March 26, 2025 MTC Commission Board meeting

Item 7a MTC Resolution No. 4537, Revised.

Major Project Advancement Policy: Stage Gate Evaluation and Recommendations for Transbay Joint Powers Authority - the Portal Project

2015 DTX draft SEIR

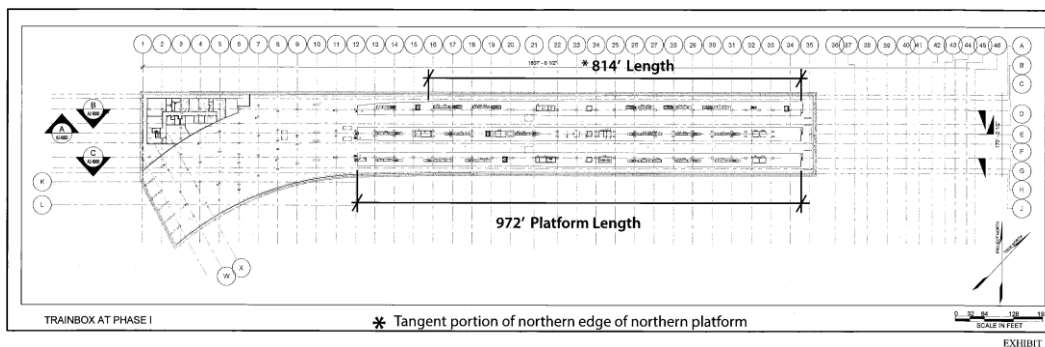
The last diagram in the letter shows that **the shortened platforms cannot possibly accommodate a 1,350-foot long Brightline West double-consist** even though the box as currently constructed is 1,530 feet long.

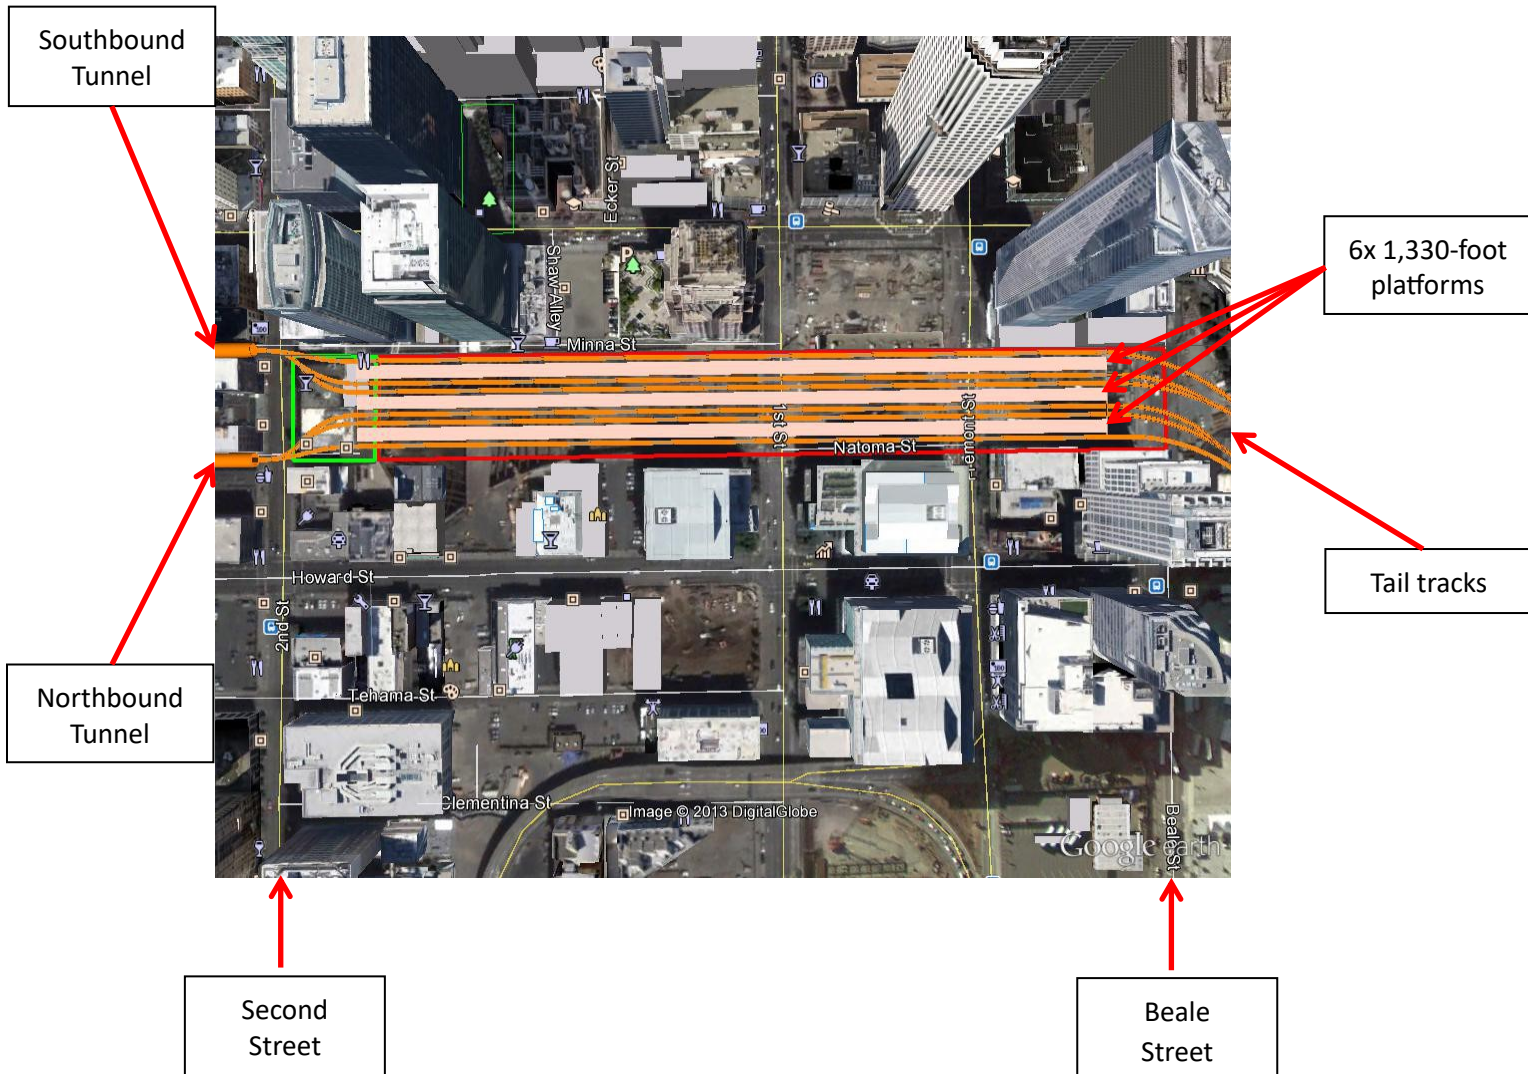
I respectfully urge the commission to consider approving the advancement of the Portal (formerly known as the Downtown Extension or DTX for short) project to the next MAP Level with conditions and recommendations along the lines suggested in the 2015 SEIR which introduced a twin-bore alignment designed to resolve the above fatal flaw while enabling a future connection to the East Bay (LINK21) as mandated by SB916. [https://hsr.ca.gov/wp-content/uploads/2022/05/Final EIRS FJ V4-09 Ch 24 IndividualComments.pdf](https://hsr.ca.gov/wp-content/uploads/2022/05/Final_EIRS_FJ_V4-09_Ch_24_IndividualComments.pdf) (page 94) attached for your convenience.

“The SEIR should consider an alternate DTX alignment which would enable platform lengthening by extending the train box one block west (towards 2nd Street) while simultaneously providing a viable connection to a Transbay tunnel. This alignment would also eliminate conflicts with the 201 Mission building and enable a 6th full-length through platform (total 3 eastbound and 3 westbound platforms).”

1) Train Box Extension

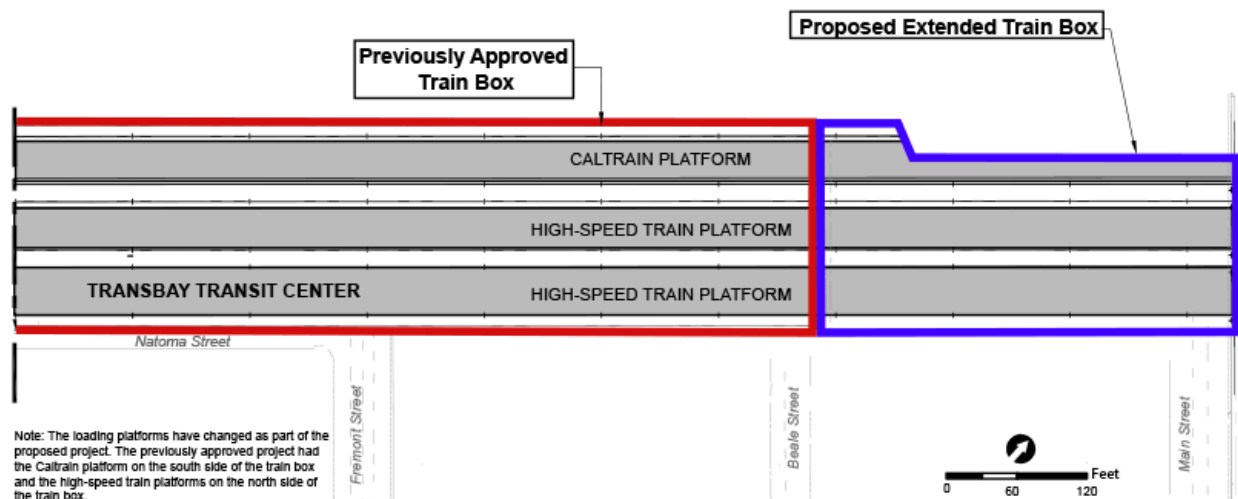
- The train box extension design violates SB916 (2003) codified in Streets & Highways Codes section 30914(22) (<http://law.justia.com/codes/california/2011/shc/division-17/30910-30922/30914>) by failing to provide any kind of engineering solution for a future East Bay extension

Recommendation #1

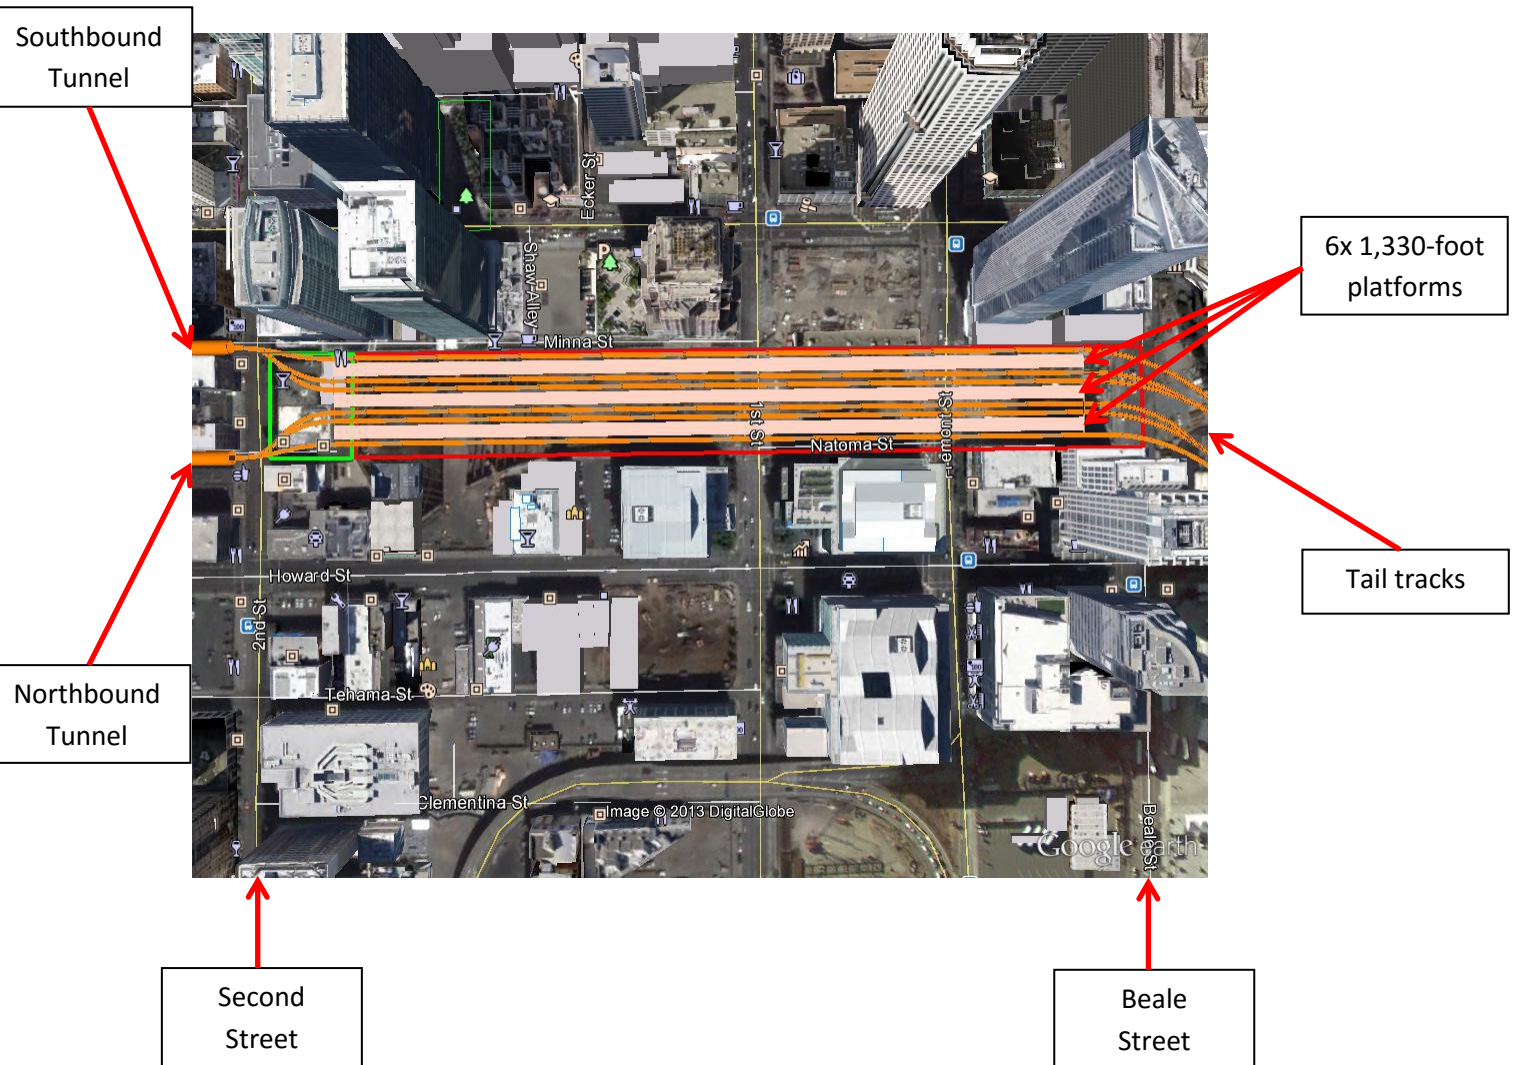
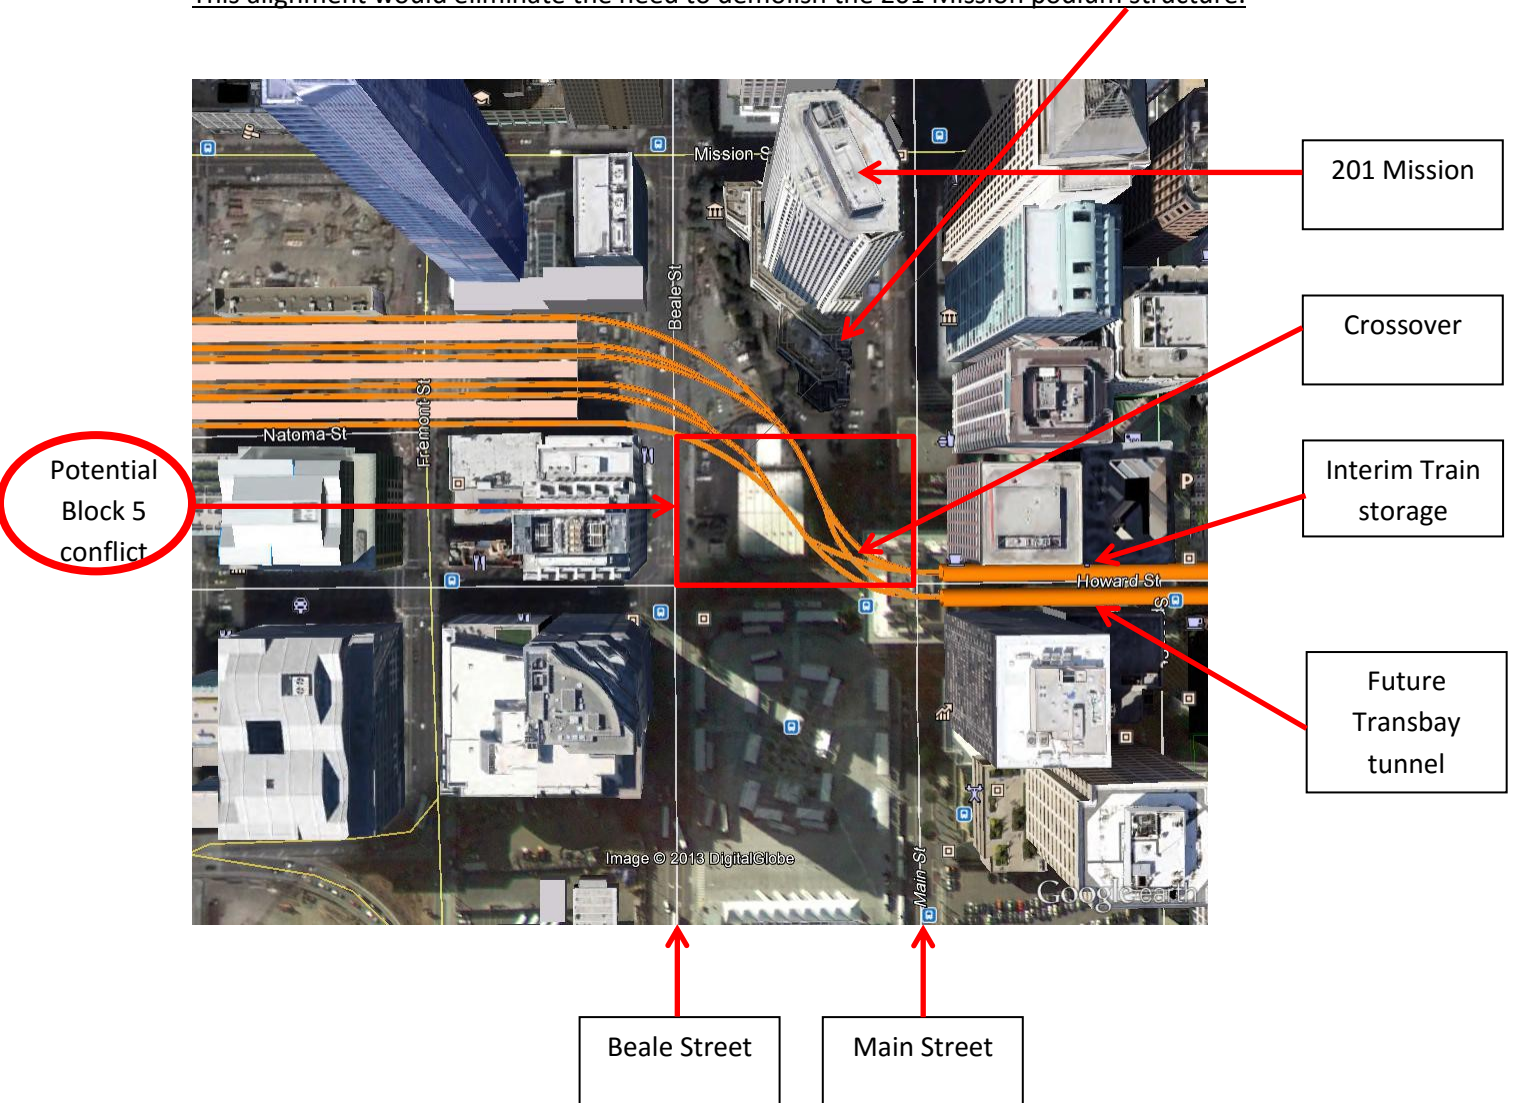
The SEIR should consider an alternate DTX alignment which would enable platform lengthening by extending the train box one block west (towards 2nd Street) while simultaneously providing a viable connection to a Transbay tunnel. This alignment would also eliminate conflicts with the 201 Mission building and enable a 6th full-length through platform (total 3 eastbound and 3 westbound platforms).

This alignment would eliminate the need to demolish the 201 Mission podium structure.

2) Widened throat structure

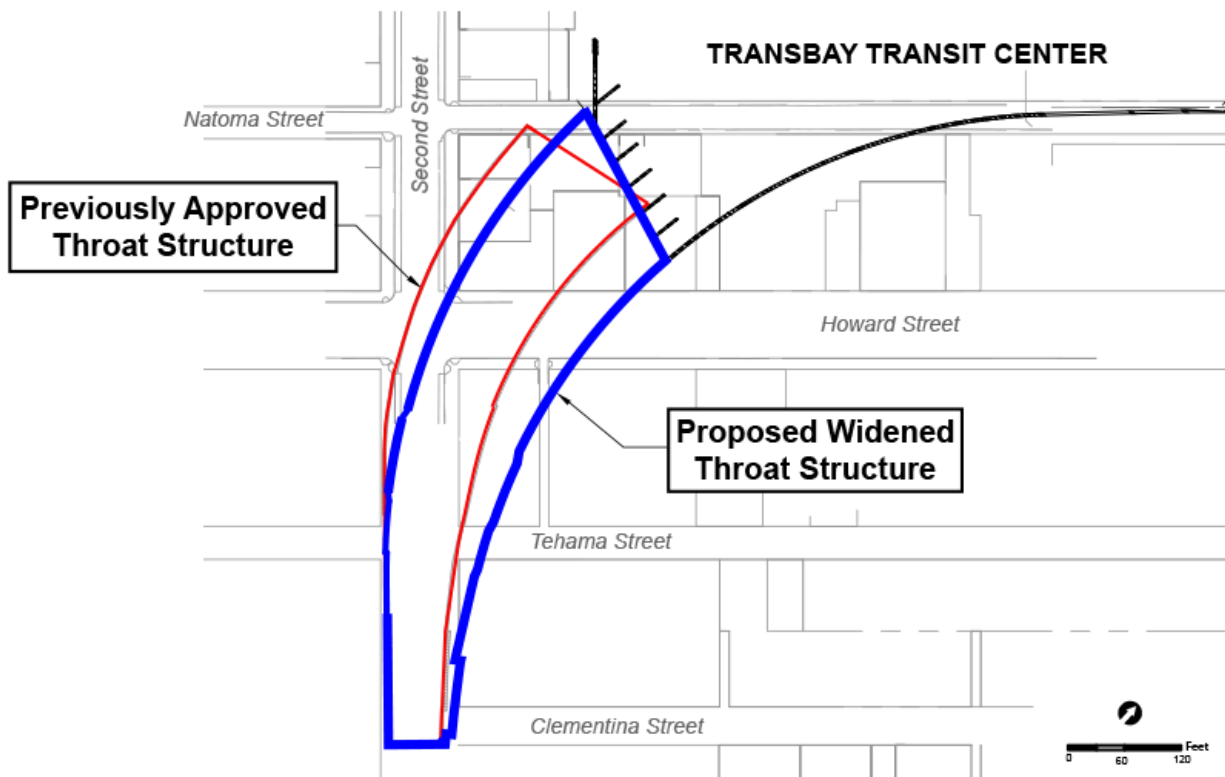
The SEIR proposes a widened approach to the Transbay Center train box via a massive cut & cover structure that will impact numerous properties as far south as Clementina Street. Construction costs are expected to run into the hundreds of millions and will result in massive circulation and noise impacts on the adjacent neighborhoods for many years.

Recommendation #2

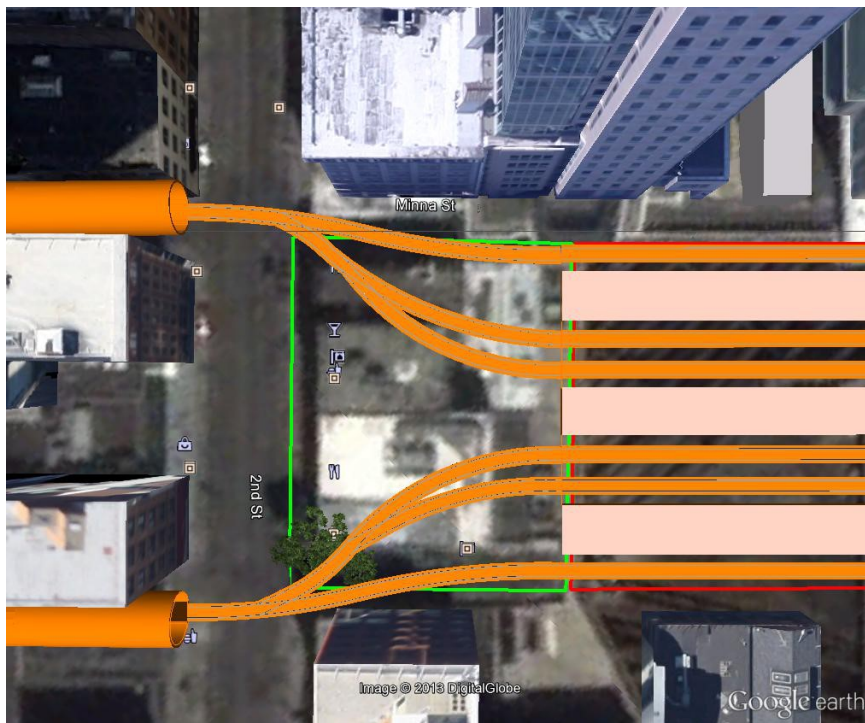
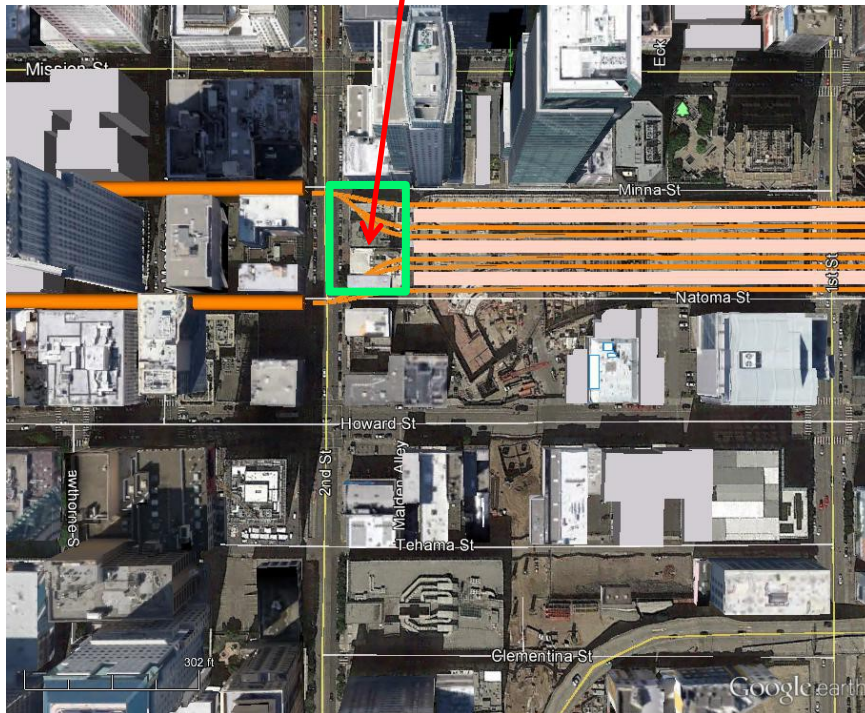
The SEIR should consider an alternate DTX alignment and construction technique that would limit impacts to a small number of buildings on 2nd Street between Minna and Natoma.

There would be no additional surface impacts in SOMA north of Townsend.

3) Tunnel design

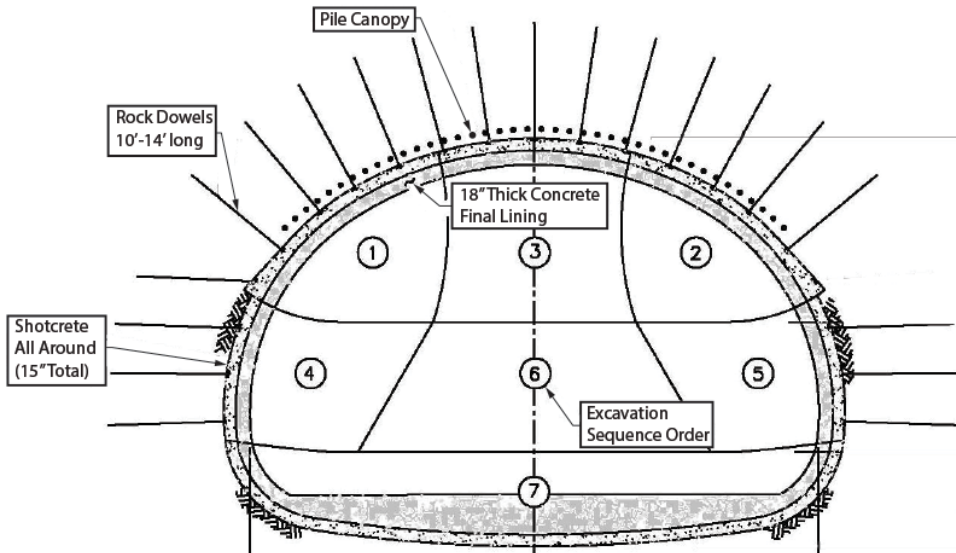
The current DTX design contemplates the construction of a 3-track sequentially excavated tunnel without any apparent plans for the evacuation of a train travelling on the middle track. This is of particular concern with High Speed trains which have a single door per carriage.

The SEIR should consider a twin-bore tunnel design with cross-passages for emergency evacuation (similar to the Central Subway) and a ventilation system designed to eliminate any requirement for vent/evacuation structures north of Townsend.

4) Fourth and Townsend Underground Station location

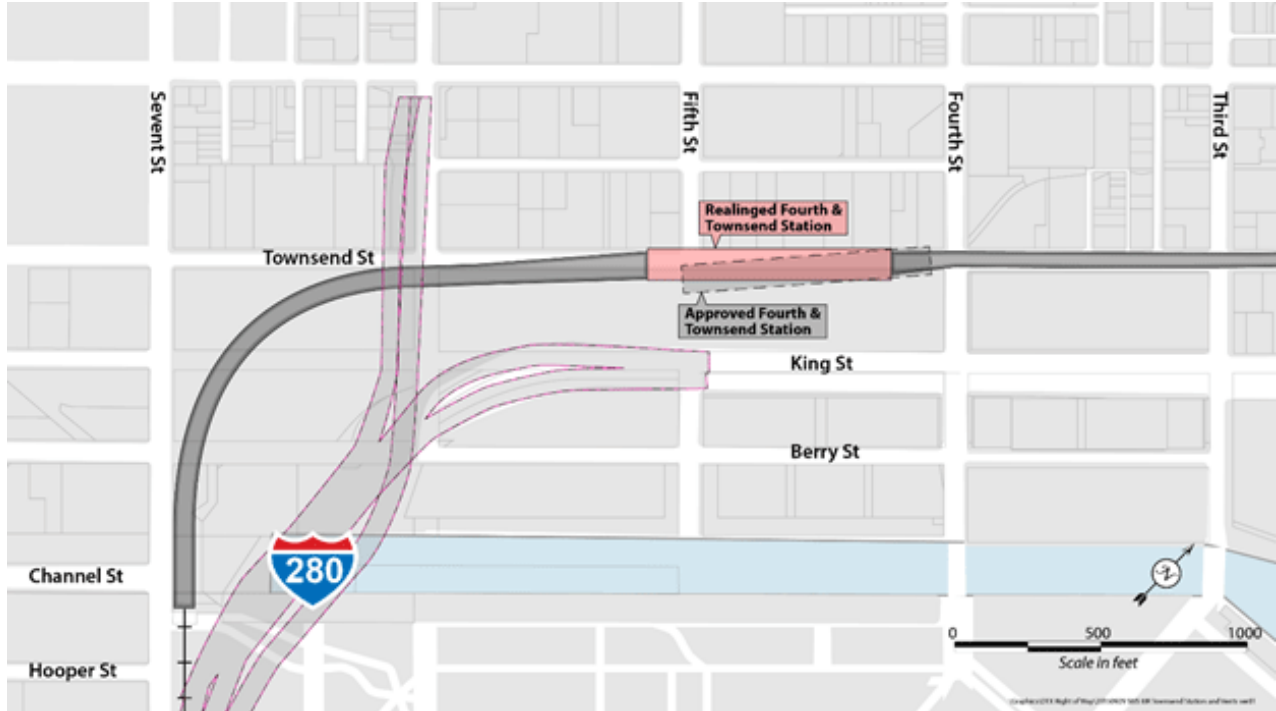
It is unclear how a relocated Caltrain station on Townsend could possibly accommodate the ridership demand from Mission Bay including UCSF, AT&T Park and the proposed Warriors Arena.
